CITY OF CHARLES TOWN
HISTORIC LANDMARKS COMMISSION
AGENDA • JUNE 10, 2024

Date: For the June 10, 2024, Historic Landmarks Commission meeting
Applicant: Jenkins Restoration
Property Owner: HASLE JAMES & AUDREY
Report by: James Newman, City Planner, Zoning/Subdivision Administrator
Proposal: Certificate of Appropriateness for exterior alterations
Property Location: 400 E. Liberty St, TD: 03 / Map: 2 / Pcl: 226
Current Zoning: Old Town Residential (OT-R)

The applicant is proposing to remove and replace exterior walls to enhance structural stability, and to add stairs and a door to second floor to allow for improved ingress/egress for access and safety.

DEMO AND REPLACEMENT PLAN - FIRST FLOOR BATHROOM EXTERIOR WALLS

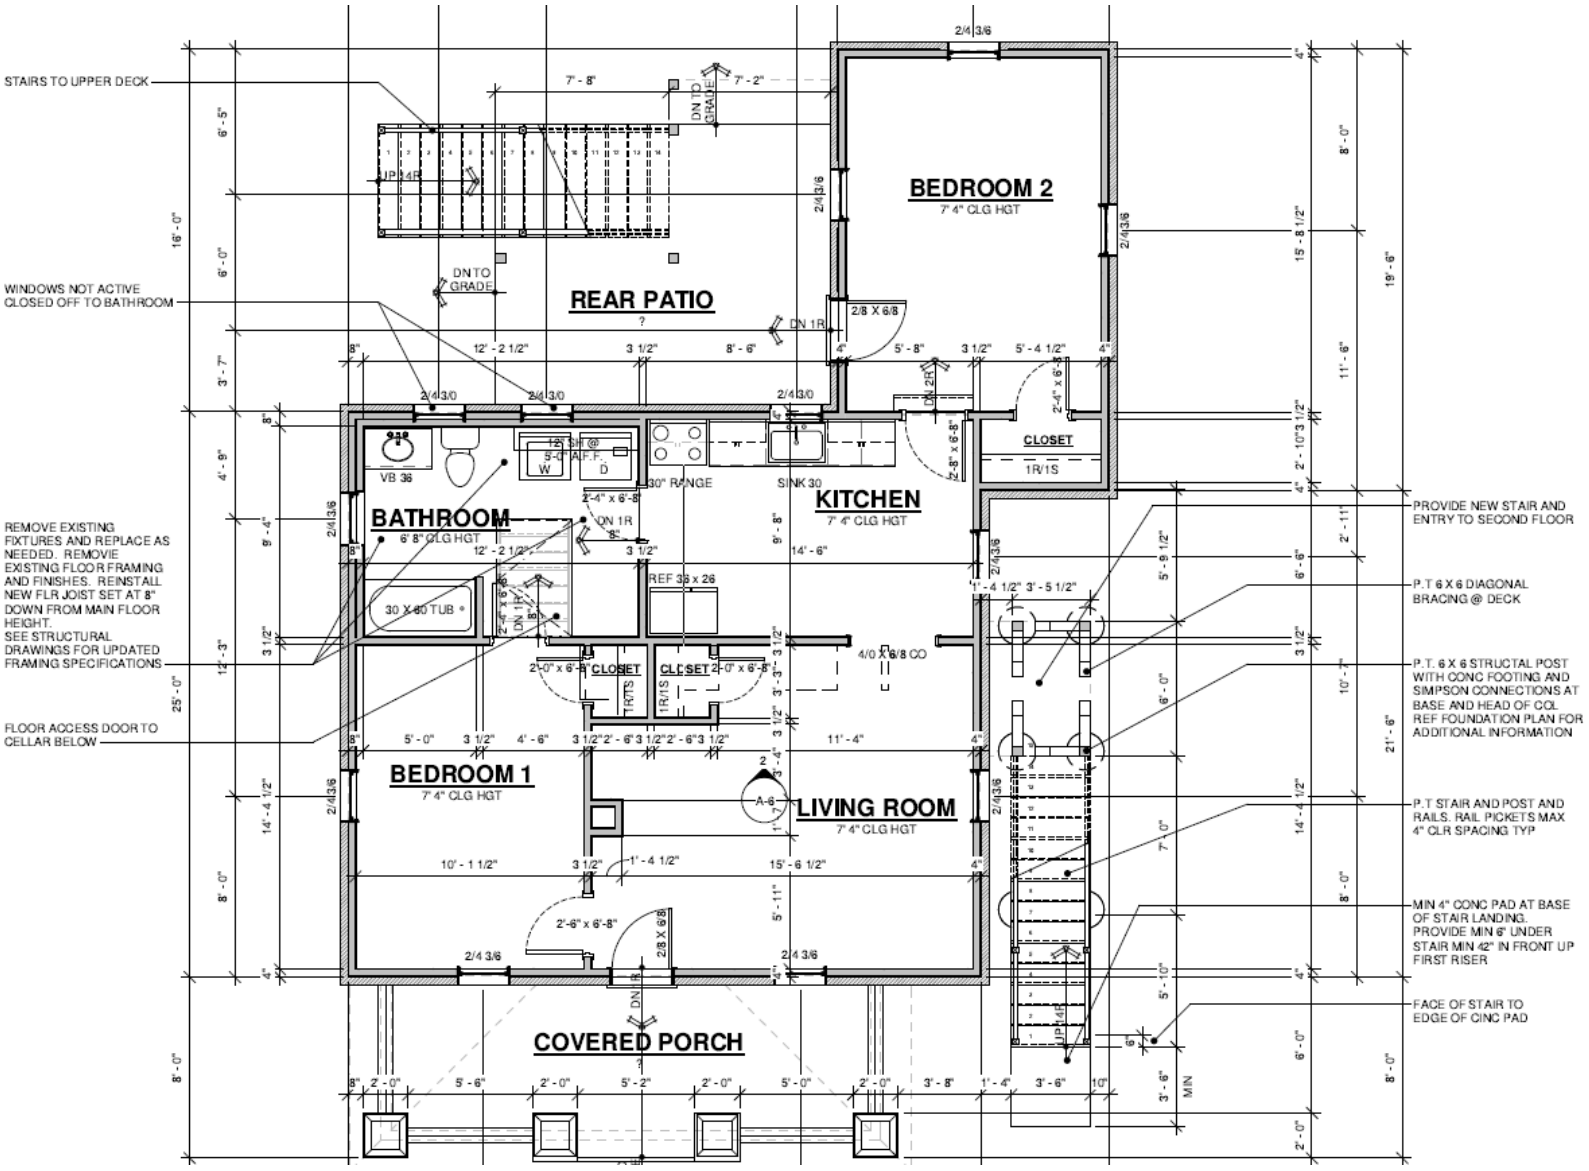
The proposed demolition will strengthen the foundations of the building and provide a safe means on ingress/egress to the second floor.

NEW CONSTRUCTION – EXTERIOR STAIRS TO SECOND FLOOR

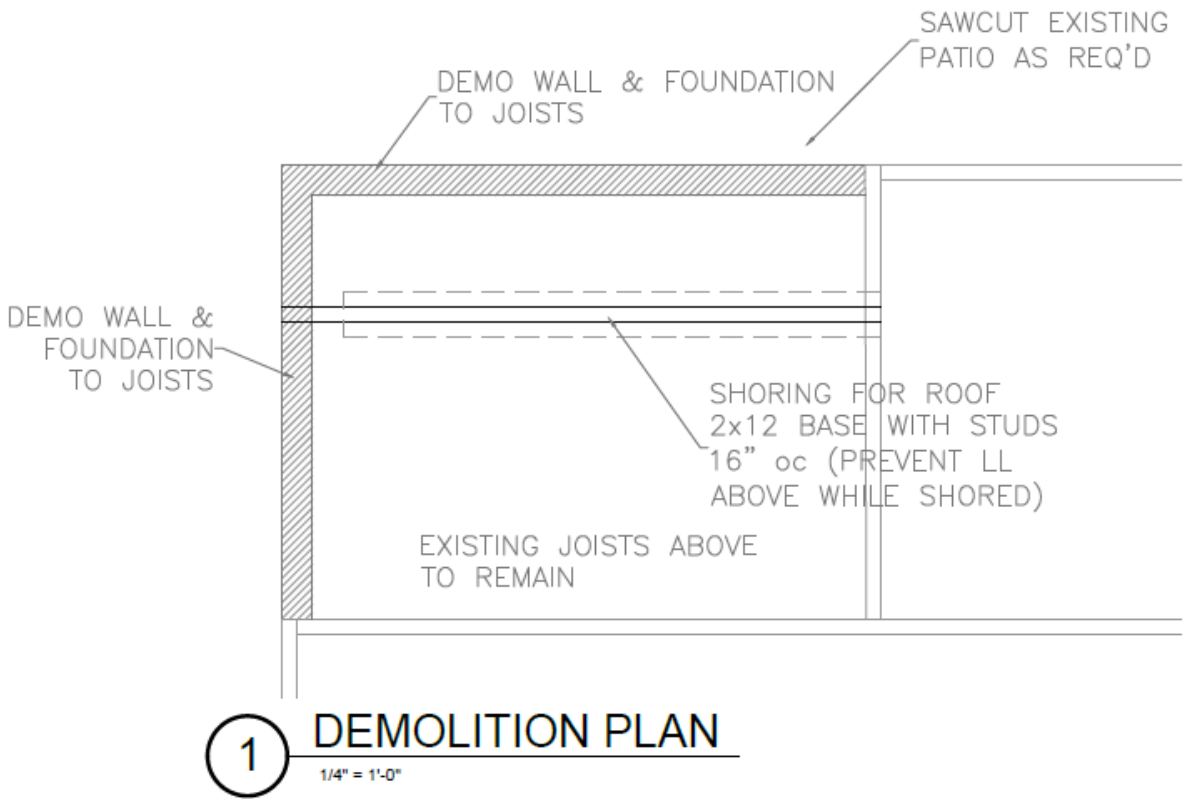
1. **Window replacement with door**
   The applicant seeks to remove a window on the second floor and replace it with a 3ft wide door leading to an exterior landing and stairs.

Per the design guidelines: "*The CTHLC generally will not approve creation of new window openings, enlargement of historical window openings or eliminating existing historical window openings. Any such request shall require extensive documentation, including architectural renderings and explaining why such elimination, enlargement or new opening is needed. The onus will be on the applicant to detail the need.*"

The stairs will provide an second means of ingress/egress beyond the existing stairs in the rear of the house. The proposed door and stairs provides a quicker route of egress form the 2nd floor bedroom in event of a fire or other disaster.

EXISTING STRUCTURE – Staff Pictures of June 6, 2024

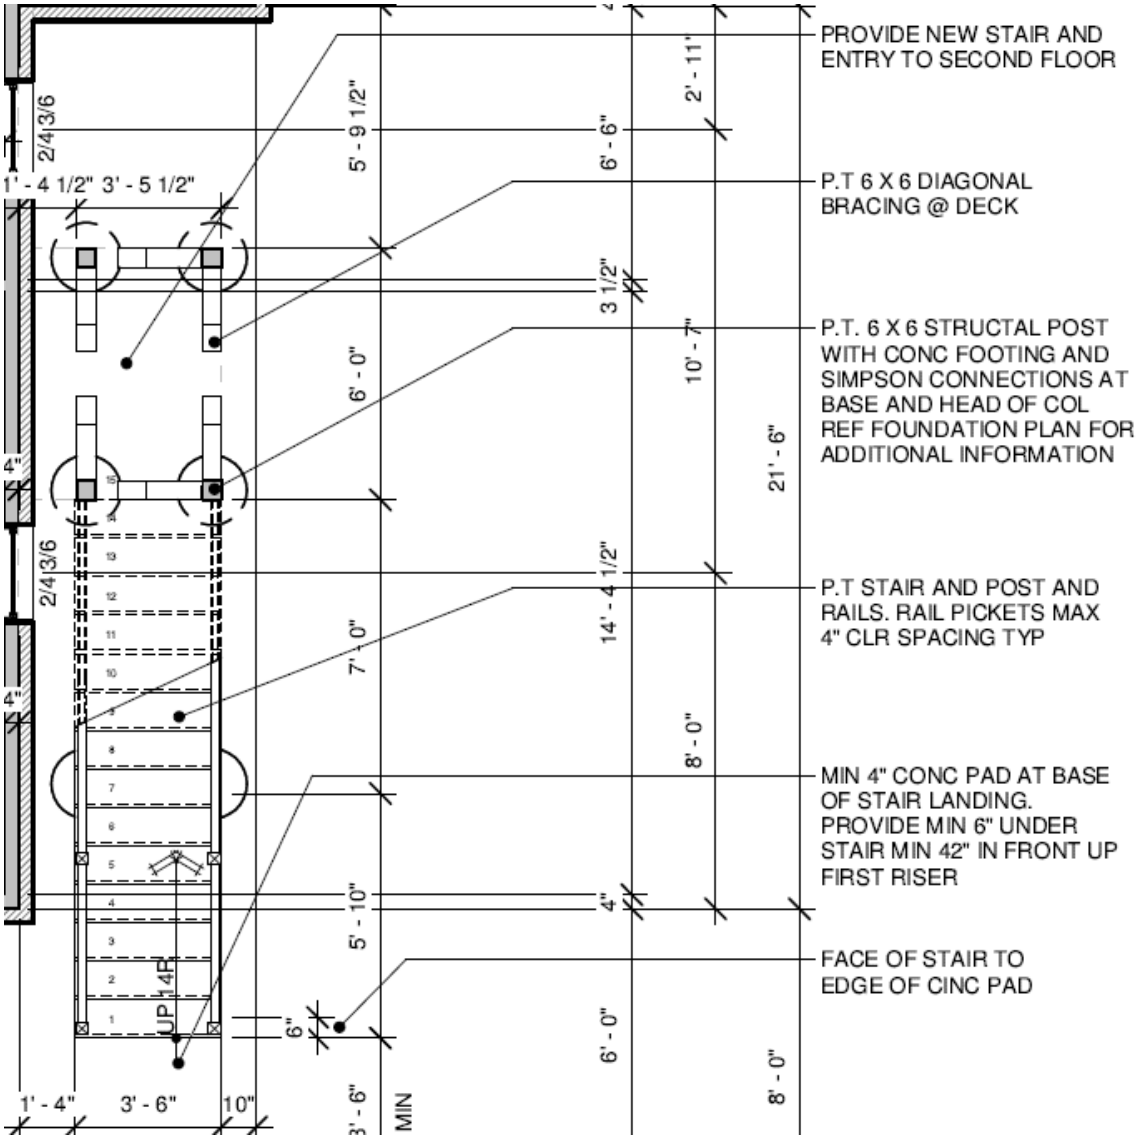
Right/east wall where stairs are to be placed and exterior door added onto second floor.

The structure has been modified with in the past without permits. Not all work was done according to Code, and not all tenants have treated the building in a safe manner, with interior additions and demolitions committed without permits.
